Work Order ID 72491

Item Name: Crosstube Turning Detail

DRAWING NO. D407-667-245	TITLE CROSSTUBE ASSY (407 HIGH AFT)	REV. F	DART AEROSPACE LTD ENGINEERING ORDER		D.E.O. NO. D407-667-245-F-1	SHEET NO. SHEET 1 OF 2	SCALE NTS
DRAWN <i>JS</i>	CHECKED <i>JP</i>	MFG. APPR. <i>BE</i>	APPROVED <i>JP</i>		DE APPR. <i>JP</i>		
DATE 11.04.08	DATE 11.04.12	DATE 11.04.12	DATE 11.04.12		DATE 11-04-12

PURPOSE:

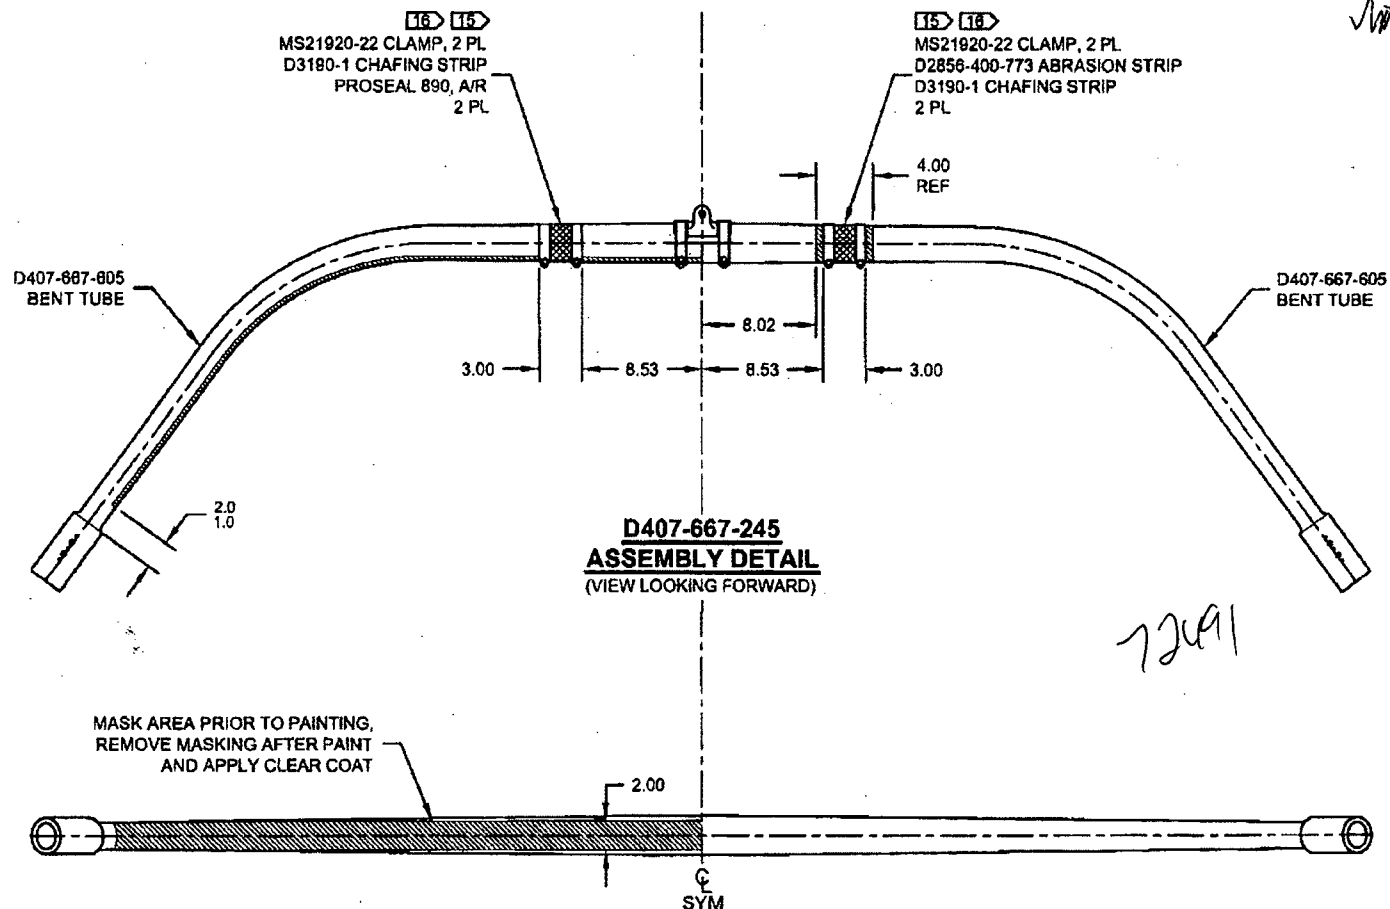
REMOVED ABRASION STRIP IN FAVOR OF A THIN LAYER OF PROSEAL 890.

NOTES 2 AND 15, SHEET 1 ARE AMENDED AS FOLLOWS:

- 2) FINISH: CHEMICAL CONVERSION COAT PER DART QSI 005 4.1
PRIME INSIDE AND OUTSIDE PER DART QSI 005 4.2
MASK UNDERSIDE OF CROSSTUBE AS SHOWN (HATCHED AREA) AND
PAINT OUTSIDE PER DART QSI 005 4.2
REMOVE MASKING AND APPLY CLEAR COAT
- 15) APPLY A THIN COAT OF PROSEAL 890 ON INSIDE CONCAVE SURFACE OF D3190-1
CHAFING SHIELDS AND LET CURE PER MANUFACTURER'S INSTRUCTIONS. INSTALL
PROSEALED D3190-1 CHAFING SHIELDS ONTO CROSSTUBE BY APPLYING A THIN COAT
OF PROSEAL 890 ONTO CROSSTUBE. BE SURE TO ELIMINATE ANY AIR GAPS.

- 2) FINISH: CHEMICAL CONVERSION COAT PER DART QSI 005 4.1
PRIME INSIDE AND OUTSIDE PER DART QSI 005 4.2
PAINT OUTSIDE PER DART QSI 005 4.2
- 15) INSTALL D2856-400-773 ABRASION STRIP WITH A 0.13 REF GAP ON BOTTOM SIDE OF
CROSSTUBE PER QSI 035.
